Solihull MBC Local Plan Publication Stage Representation Form

Draft Submission Local Plan

Name or Organisation: **Cllr Richard Lloyd**

Figure 1

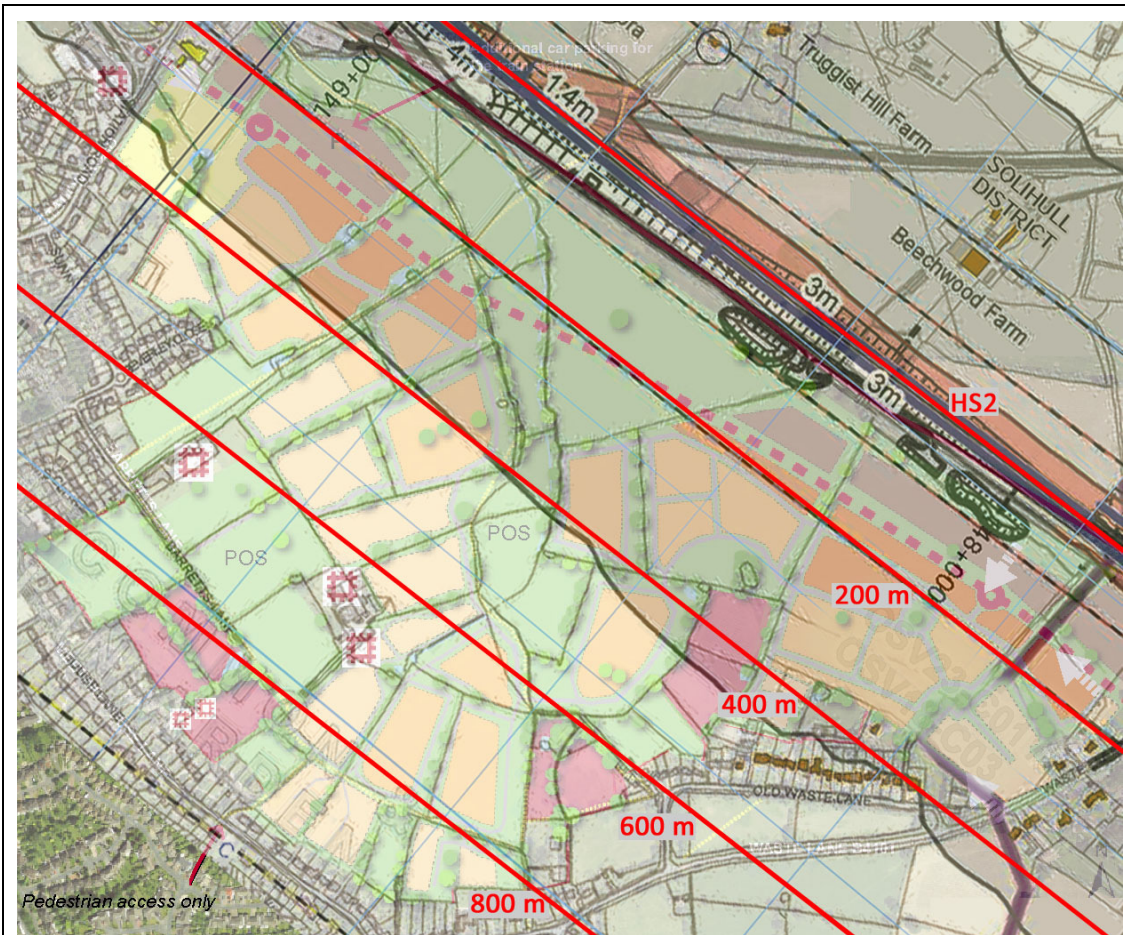
Section 180 of the NPPF (2019) states "new development should ... avoid noise giving rise to significant adverse impacts on health and the quality of life". However, HS2 map SV-05-050b shows much of the BC1 site is within a noise contour where residential and school development should be ruled out.

Figure 1, below, shows the HS2 "Operational Noise and Vibration Impacts and Likely Significant Effects" map SV-05-050b overlaid on the plan for BC1 from the Concept Masterplan book p16.

Distances from the HS2 line are marked in red. The HS2 noise contour - seen as a dark grey line roughly 400 m from the HS2 alignment - encloses all the high density housing (dark orange), half the medium density housing (mid orange), and most of the primary school and nursery (light yellow). All the medium density housing and much of the low density housing (light orange) are within 800 m of the line.

The grey HS2 noise contour is described in the HS2 Environmental Statement as enclosing the predicted 50 to 65 dB LpAeq daytime zone and 40 to 55 dB LpAeq night-time zone. The World Health Organisation states that when the average (continuous-equivalent) night noise level is 40 to 55 dB, "Adverse health effects are observed among the exposed population. Many people have to adapt their lives to cope with the noise at night. Vulnerable groups are more severely affected." (*Night Noise Guidelines for Europe*, 2009)

On the north-east side of the line (toward Beechwood Farm, in Figure 1, above), HS2 Ltd shows a contour of 65 dB L_{pAeq} at about 50 m from the line, as well as the 50 dB L_{pAeq} contour typically around 400 m from the line. The 15 dB difference exactly matches the diminution of noise with distance just quoted.

However, the absence of the higher 65 dB L_{pAeq} contour on the south-west side highlights the sensitivity of the modelling to the assumed ground profile. The HS2 prediction assumes open farmland, and is for a noise receptor at ground level.

From the NPPF requirements, housing has to be confined to a zone where noise insulation is not required. The number of planned dwellings will have to be reduced, so section 1 of the Policy should be amended to read:

"The site is allocated for 200 dwellings which are ... "

The proposed school needs to be relocated, so subsection 3(i) should be amended to read:

"Contribution to provision of a new 2 form primary school and nursery outside the area affected by environmental noise; "
